Rezoning Transportation Analysis

Petition Number	2016-079	Updated	4/27/2016
Location	Approximately 18.3 Acres located on the west side of East Craighead Road between North Davidson Street and North Tryon Street		
Staff Resource	Kory Hedrick	khedrick@charlottenc.gov	704.432.6511

Curbline

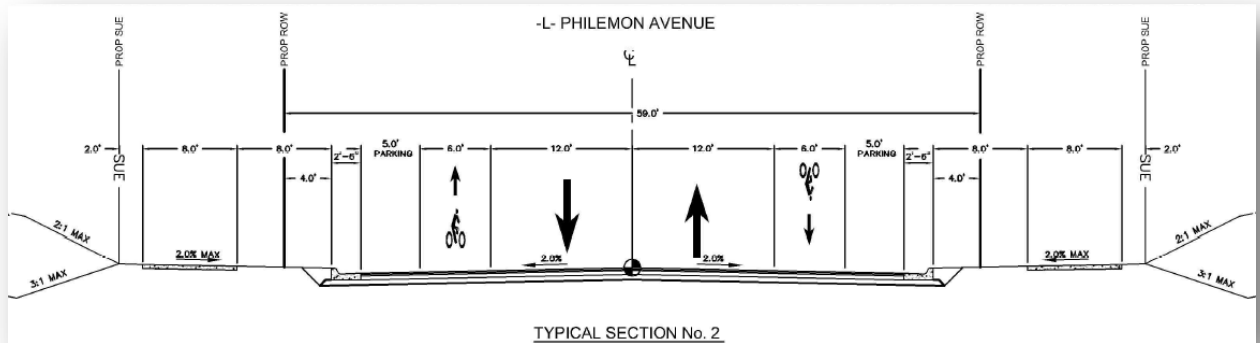
The proposed zoning district has a setback measured from an existing or proposed future curbline. The location of the future curbline is TBD (to be determined prior to public hearing).

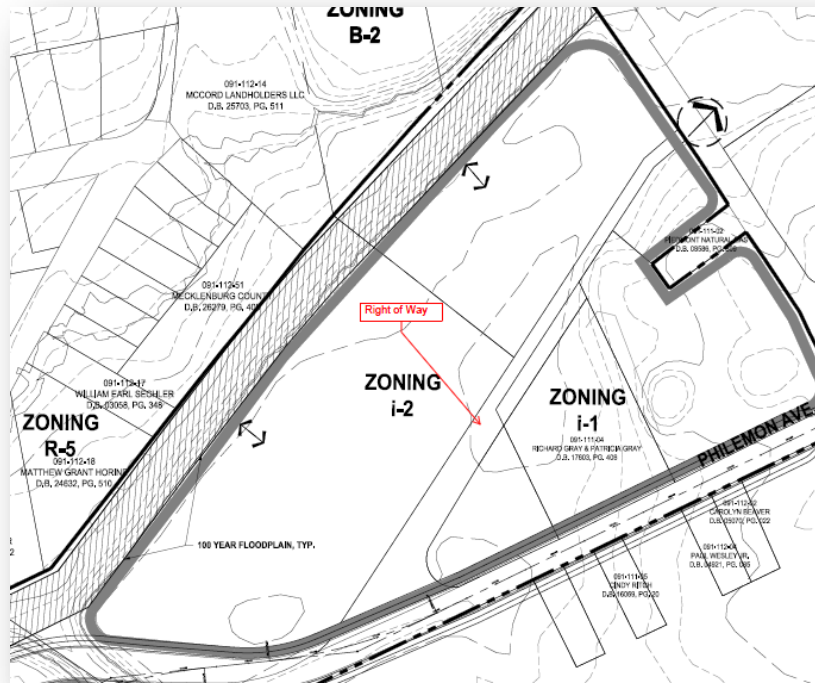
4. CDOT requests that the petitioner clarify their intent for the use of existing unused right of way (see below). The site plan proposes this right of way for site access. If that is the case what are the improvement plans for this right of way? In addition, how will it function with Philemon Ave., Craighead Rd., and the Cross Charlotte Trail?

Cross Section

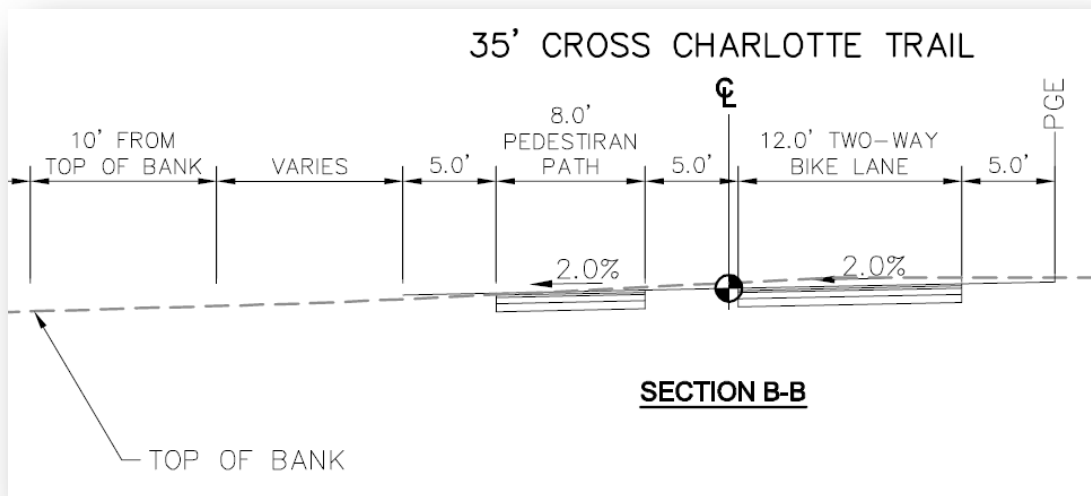
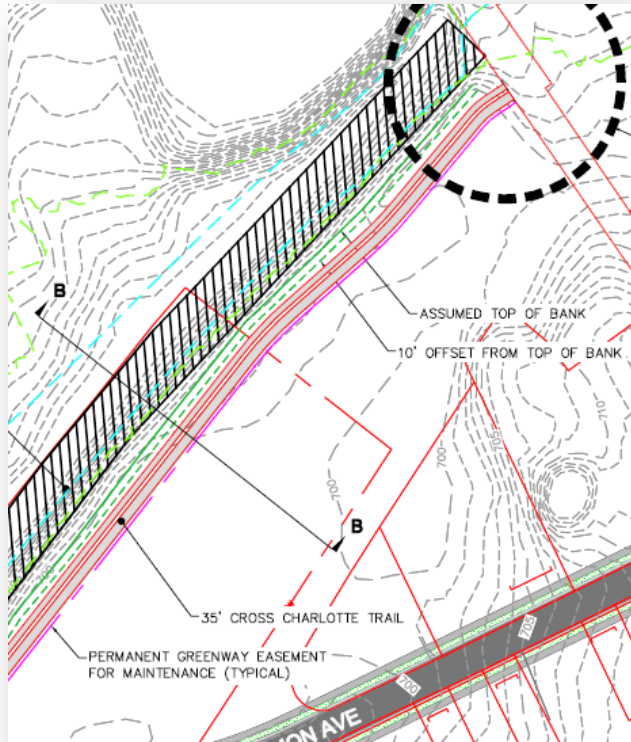
- The location on the current site plan called out for greenway preservation is not a feasible location to construct a greenway due to various environmental and physical constraints. CDOT recommends that the petitioner construct the Cross Charlotte Trail per the cross section and along the alignment shown below, including a permanent 35' easement be dedicated for future maintenance of this trail. The cross section and alignment feasibility have been studied by the Cross Charlotte Trail design team for feasibility to construct.
